AMENDMENT 2**Invitation For Bids (IFB)
UOG IFB No. B26-21**

“CUBICLE WORKSTATIONS AND METAL CABINETS”

QUESTION & ANSWER SHEET NO.2

QUESTION & ANSWER SHEET NO.1

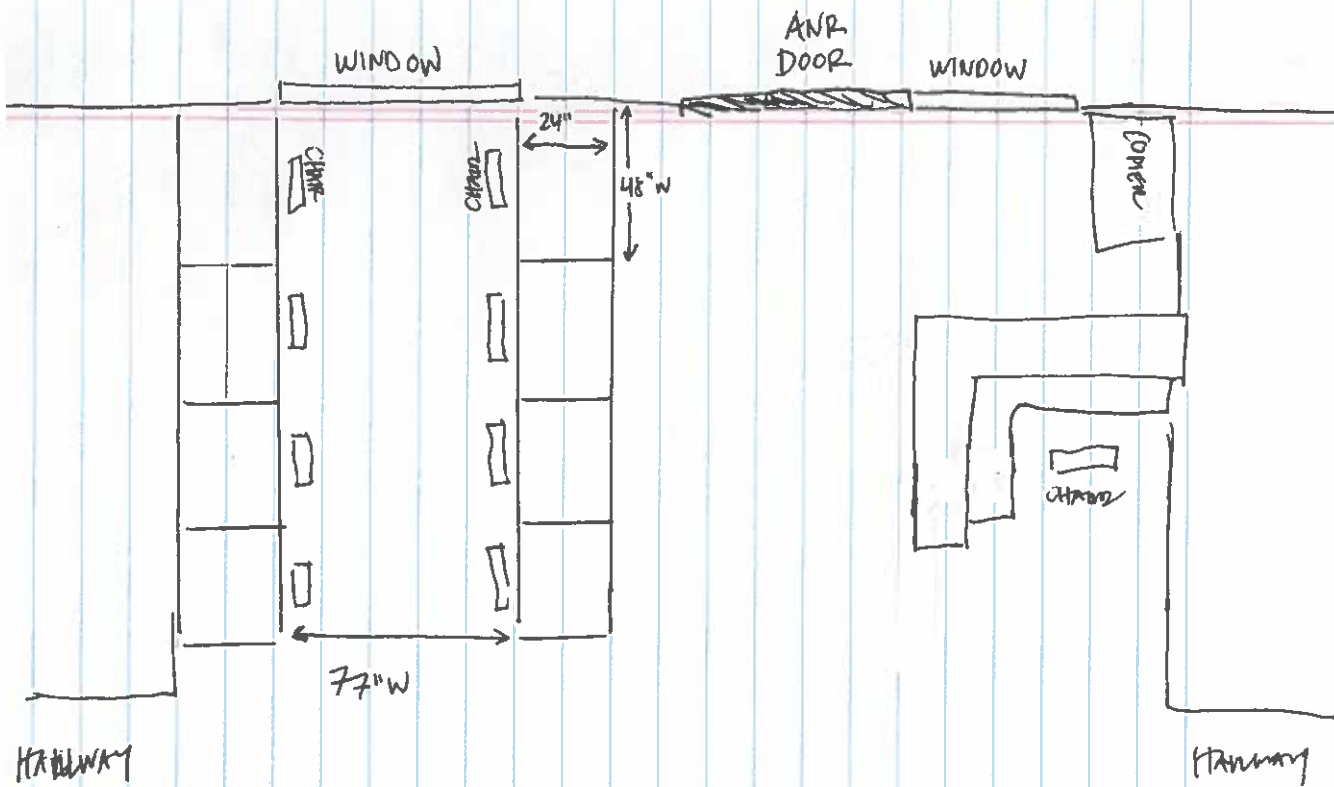
Question 1: Regarding sections 1.1 and 1.2 – relative to the 8 Cubicle Workstations: During the site visit, it was mentioned that UOG intends to repurpose the existing workstation in Room 105 as part of the modification to create eight cubicle workstations. Could you please provide the brand and model of the current workstation for quoting purposes? Additionally, are there any specific dimensions required for the eight workstations? The current specifications do not clearly indicate this information.

Dimensions: If possible, please have workstations 48" W x 24" each. The total space between each desk (across) should be 77" W. I attached a drawing for further clarification. We hope this helps.

Answer: *For clarification, the existing workstation will be reused for 1.2 where the worksurfaces will be added onto. We unfortunately cannot find any branding name or model on the workstation.*
